City of Portland, Maine - Building or Use Permit Application
 389 Congress Street, 04101 Tel: (207) 874-8703, Fax: (207) 874-8716

Permit No: 08-0364	Issue Date:	CBL: 044 H006001
-----------------------	-------------	---------------------

Proposed Project Description:
 Addition of Shed Dormer 17' long
 Dormer on #17 side + 2nd FL Bath remodel #17

PROJECT: 17 WINTER STREET
 3rd FLOOR DORMER AND ROOF
 STRUCTURAL DESIGN

ISSUE DATE: **S1.4**
SHEET 1 OF 1

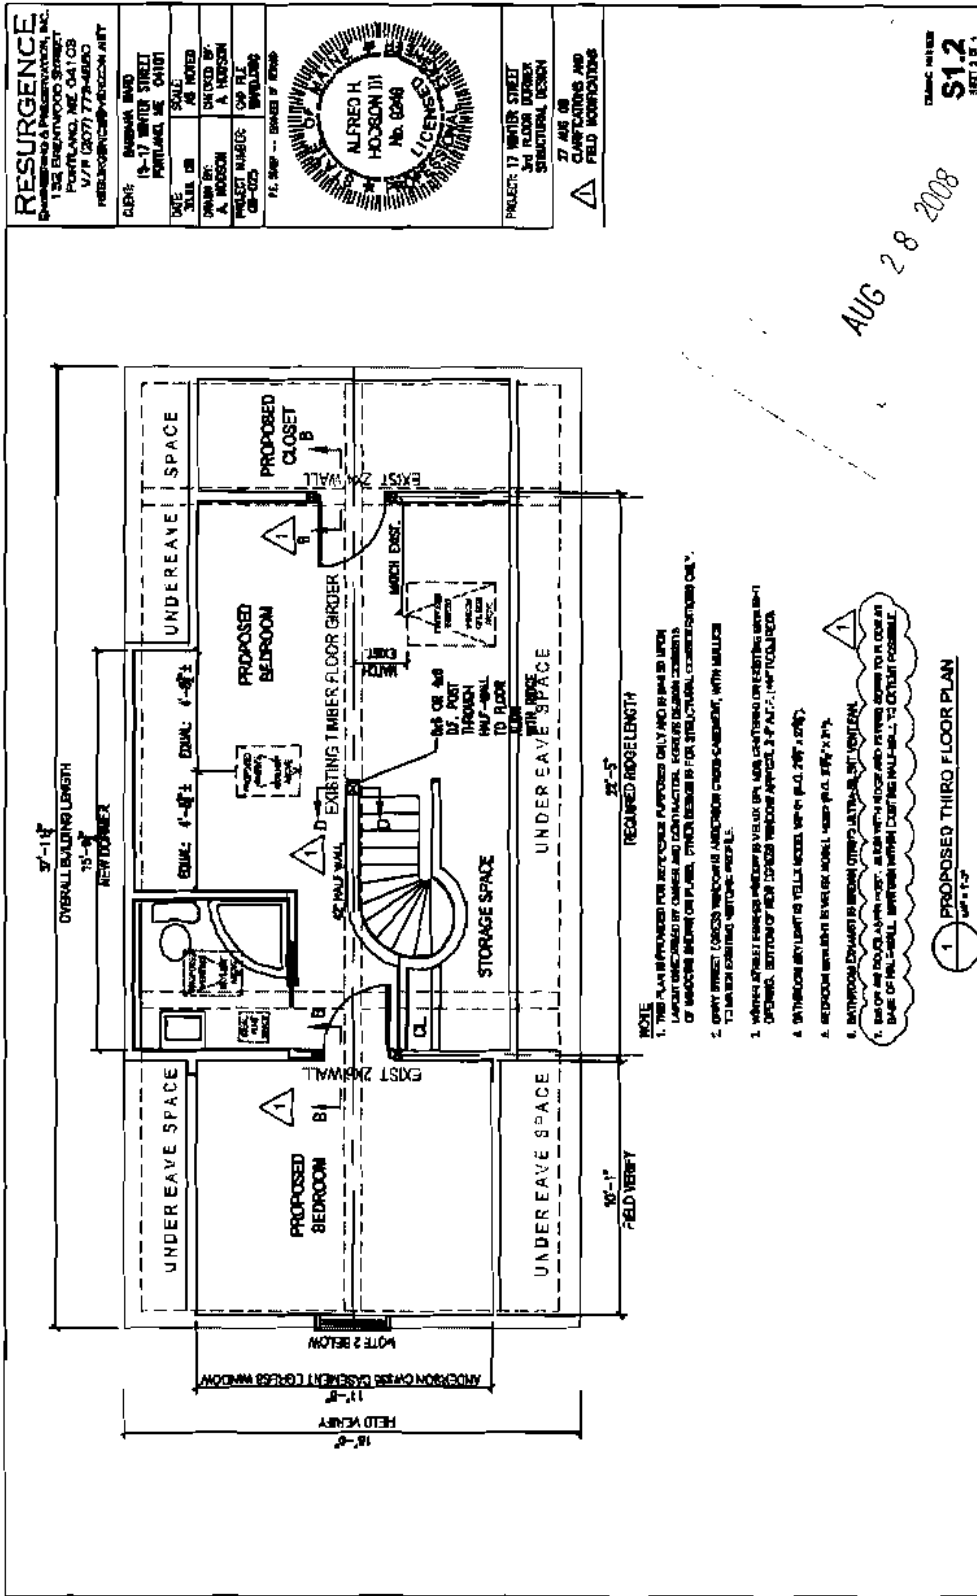
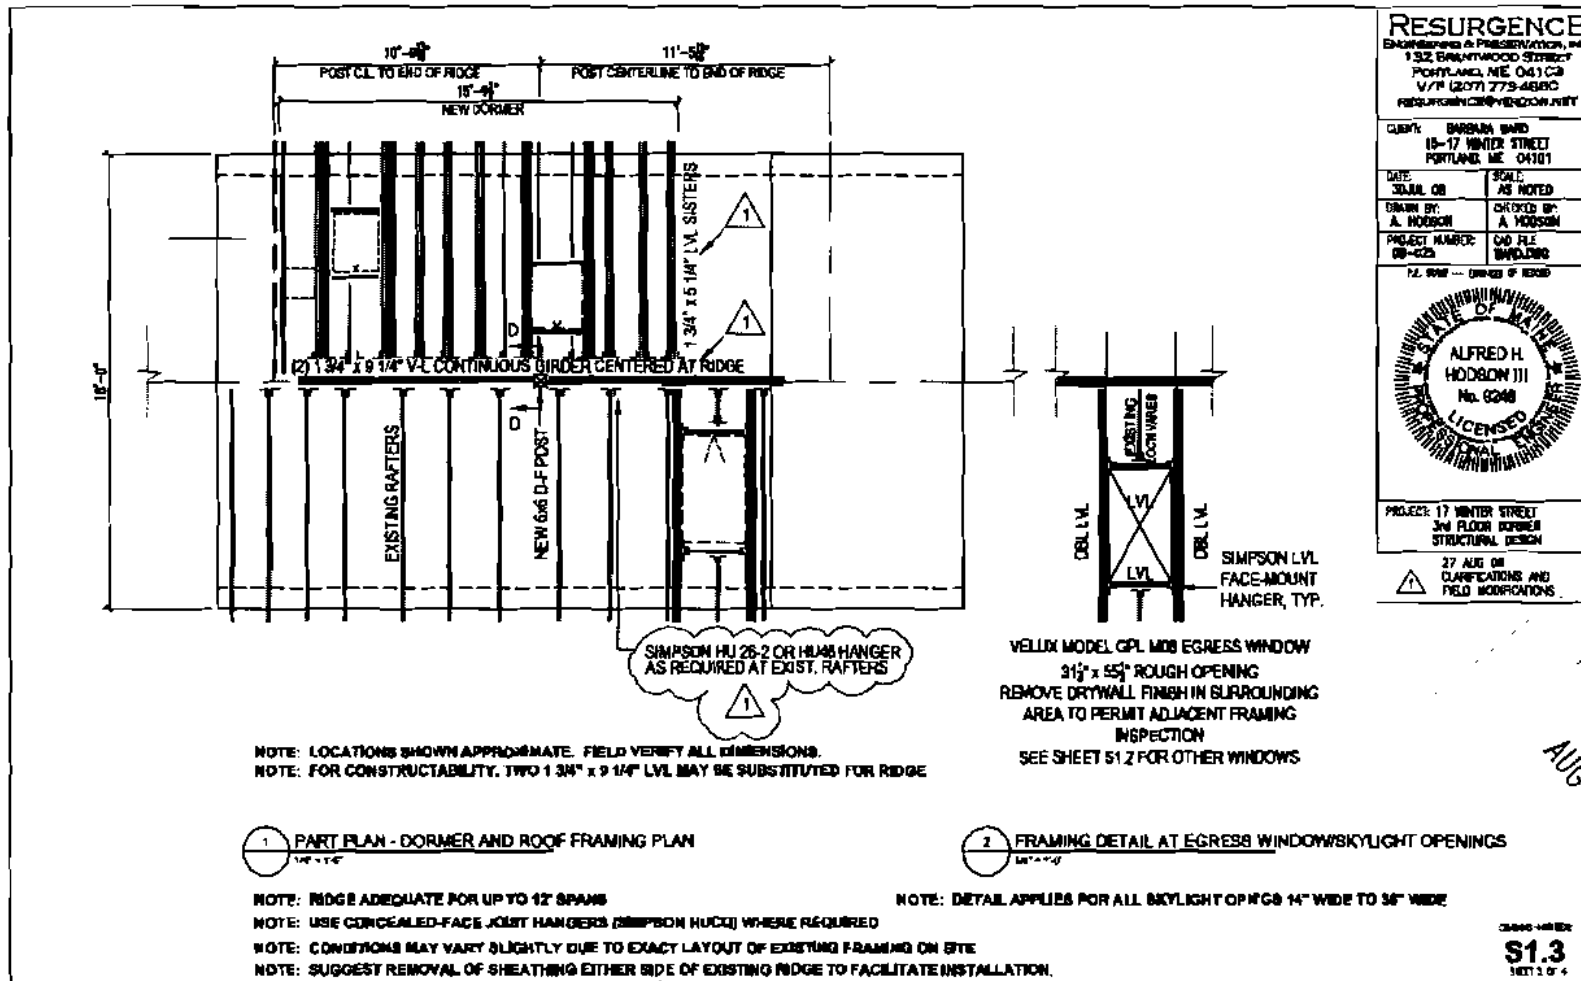
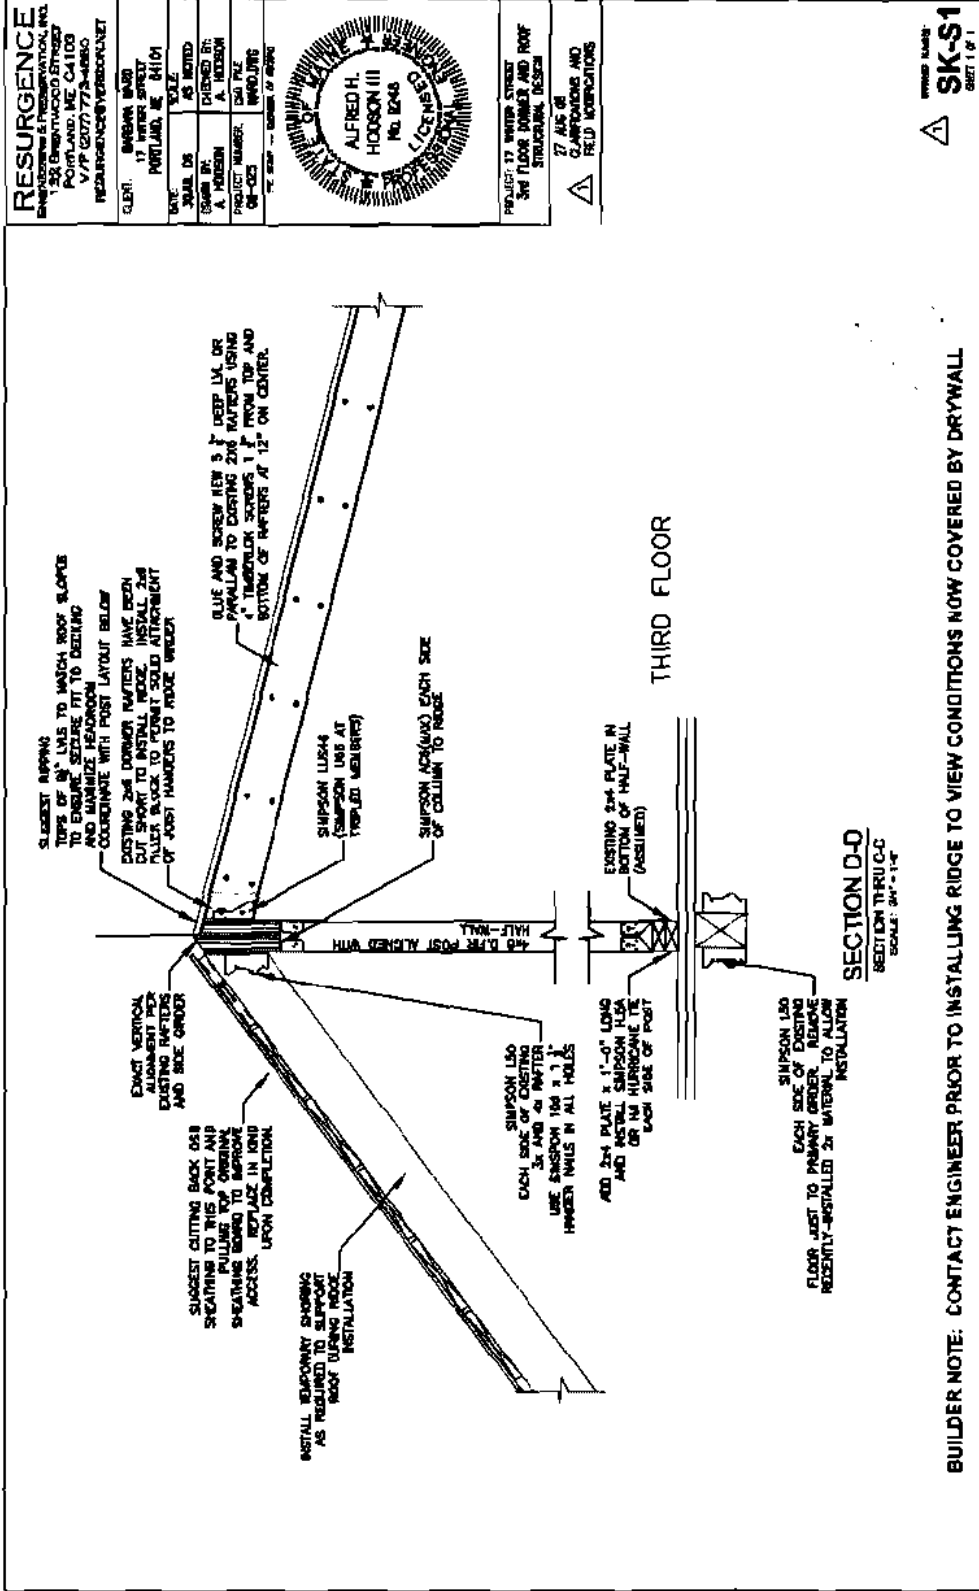
Enclosed please find revised drawings produced by Al Hodgson..the substance has not changed. We requested more detail to include location of the support pole as it relates to the half wall, location of the bath vent fan, and construction detail for our builder.

Please find attached some revised sketches per my last site visit, calling out a few more details of the ridge construction.
